**TB 193**

## TECHNICAL BULLETIN

**Product :** Stannah Midilift XLplus

**Subject :** Spacers - Driveshaft Bearing Assemblies

TABLE 1			
SLOT WIDTH	PART NO.	SPACER IDENTIFICATION	IMAGE (ALL DIMS IN MM)
18.0mm	6203211	DIA 17,5mm, NO FLAT FACES	 
16.5mm	6203359	DIA 17,5mm, 16mm ACROSS FLATS

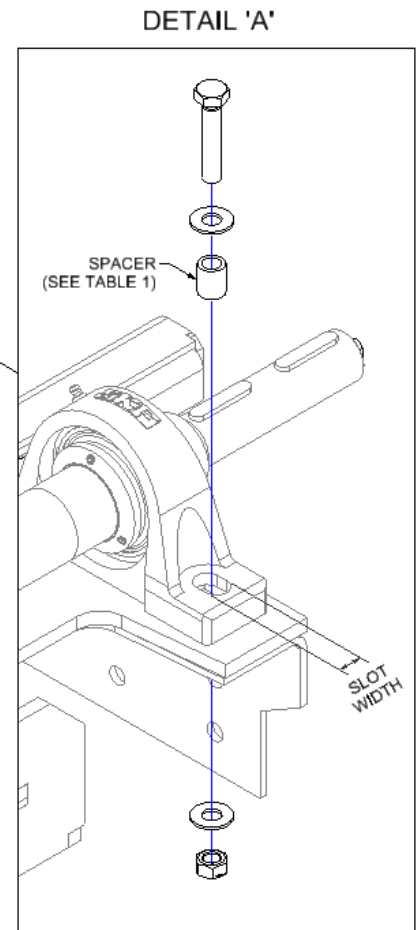
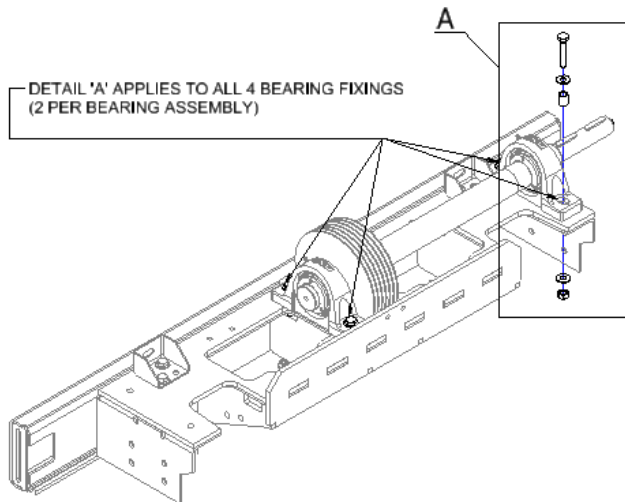
A number of XLplus driveshaft bearing assemblies, with narrower width fixing slots, are being used under concession. The narrower slots mean that the standard 17.5mm diameter spacers need to be replaced with an alternative spacer that has two flat surfaces machined on it. See page 2 for further details.

1. The M12 screws, washers and nuts remain the same regardless of slot width, it is just the spacer that differs.
2. 6203359 must not be used in bearing assemblies with an 18mm wide slot.

- Bearing assemblies with a fixing slot width of 18mm must use the standard spacer (part number 6203211)
- Bearing assemblies with a fixing slot width of 16.5mm must use the alternative spacer (part number 6203359)
